**283 and 285 McLeod Street, Ottawa**

Urban Design Brief  
Site Plan Control  
January 25, 2024

## Responses to Pre-Consultation Comments

This section provides a response to comments received from Urban Design staff on November 15, 2023, following the pre-con meeting on November 7, 2023.

Figure 2: Proposed Site Plan

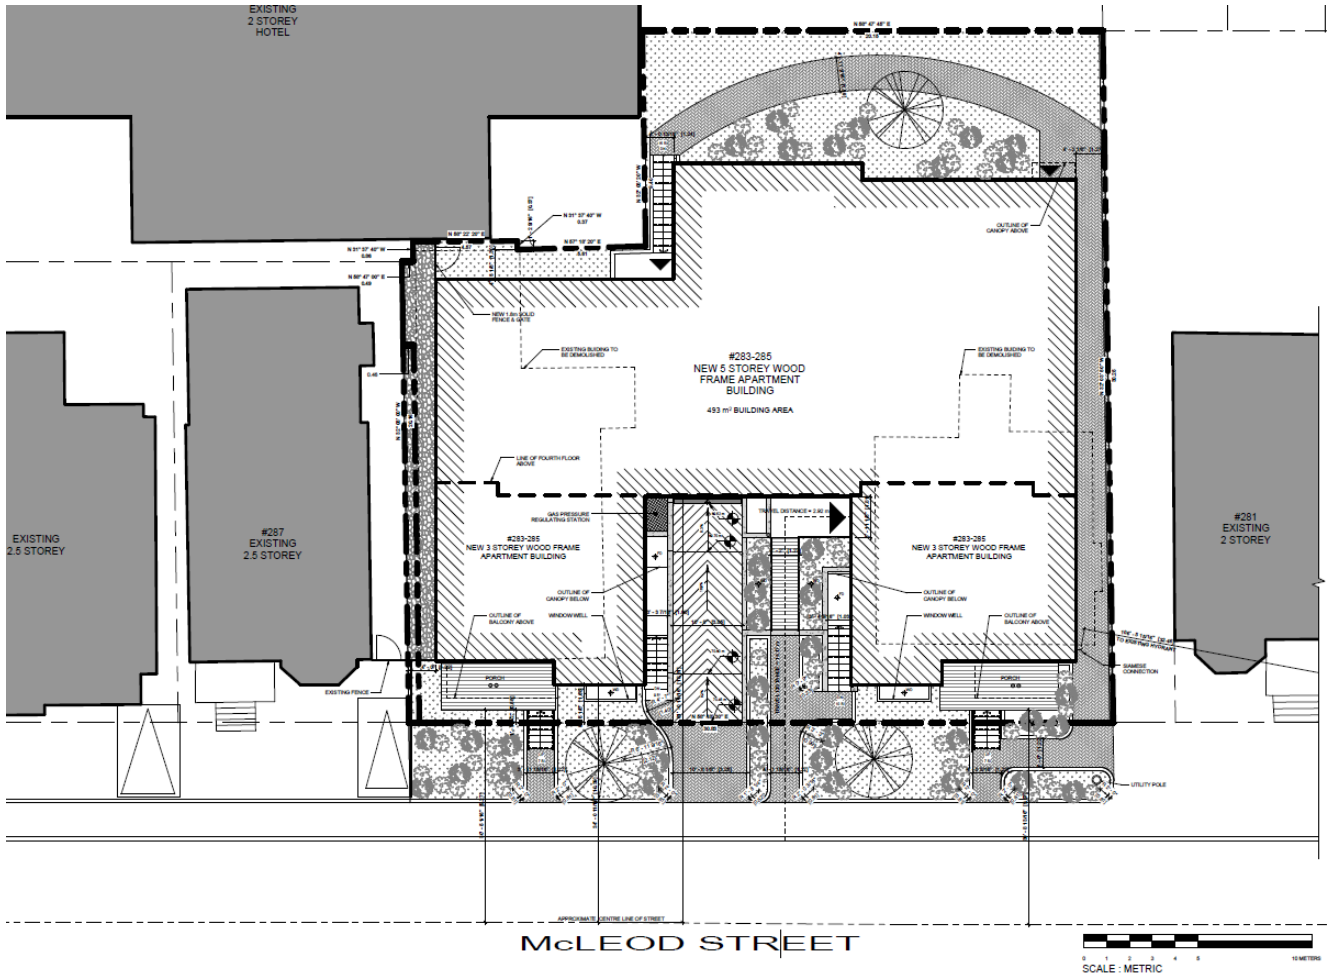
1. With regards to the sunken areas, we note that they are generally discouraged if they can be avoided.
  - a. Negative impacts to the front yard and streetscape posed by the sunken area can be avoided with appropriate landscaping treatment.
  - b. The sunken amenity area at the rear appears as though it could be avoided.

2. There are potential conflicts between automobiles and pedestrian where the sunken driveway is paired with the unit access to its left (west).

3. Ensure accessibility standards are met when considering access pathways through the site. The rightmost pathway seems to be leading to an at-grade amenity area at the rear, so accessible access should be expected.

4. Look for opportunities to consolidate walkways where/if possible.

6. Site Plan should show all applicable dimensions and setbacks. Please include a zoning matrix in future submissions which outlines how the proposed development is in conformity with the applicable zoning standards.

8. Sunken Courtyard/amenity space: We continue to have concerns about the sunken courtyard, its livability and access to natural light. We recommend removal of the rear yard amenity if it does not represent part of the required area and use the space instead for landscaping and trees. Alternatively, if the amenity is to remain at that level for accessibility reasons, consider stepping the bounding walls to create a more welcoming terraced condition.

9. Unit access adjacent to parking ramp: We continue to have concerns about the potential conflict between cars accessing the underground parking and the pedestrians accessing the conjoined western basement unit. We recommend relocating the access to a more protected location, perhaps further to the west, or providing sufficient separation between cars and pedestrians at this location.

10. Main entrance clearly visible from the street/canopy: The main entrance for the majority of the building occupants is not directly visible from the street. We recommend providing additional features (ie. Canopy and exterior lighting) to ensure visibility and visitor access consideration.

**Response: The two sunken entries located in the entrance courtyard should not have a negative impact on the McLeod Street streetscape with the implementation of appropriate landscape elements. In reality, these entrances are minimally 'sunken' as they follow the slope of the ramp allowing for an abundance of natural light into the lower level units, making them more livable. More importantly, these two entry conditions help to animate the entrance courtyard.**

**The rear yard sunken amenity space has been eliminated.**

**Response: With an appropriate curb height for the ramp, there should not be any safety issues/conflict with the two apartment entry conditions, especially given that the ramp is heated, there are only eight underground parking spaces and the ramp is 3.6 metres wide encouraging reduced vehicle speeds.**

**Response: The easterly pathway to the rear yard varies in width from 1.21m to 1.54m, however, in accordance with OADS 3.3.1 (Rest Areas), there are two 1.8m x 1.8m rest areas which are located 21 metres apart.**

**Response: Pathways have been consolidated and are consistent with the 'rhythm' of entrance pathways along McLeod Street.**

**Response: The updated Site Plan shows all required information.**

**Response: The rear yard sunken amenity space has been eliminated.**

**Response: With an appropriate curb height for the ramp, there should not be any safety issues/conflict with the two apartment entry conditions, especially given that the ramp is heated, there are only eight underground parking spaces and the ramp is 3.6 metres wide encouraging reduced vehicle speeds.**

**Response: The following elements have been incorporated to 'announce' the apartment entry:**

- **A Canopy**
- **A Sculpture, with a possible wall fountain**
- **Night lighting**
- **Alignment of the entrance pathway, including its bridge**
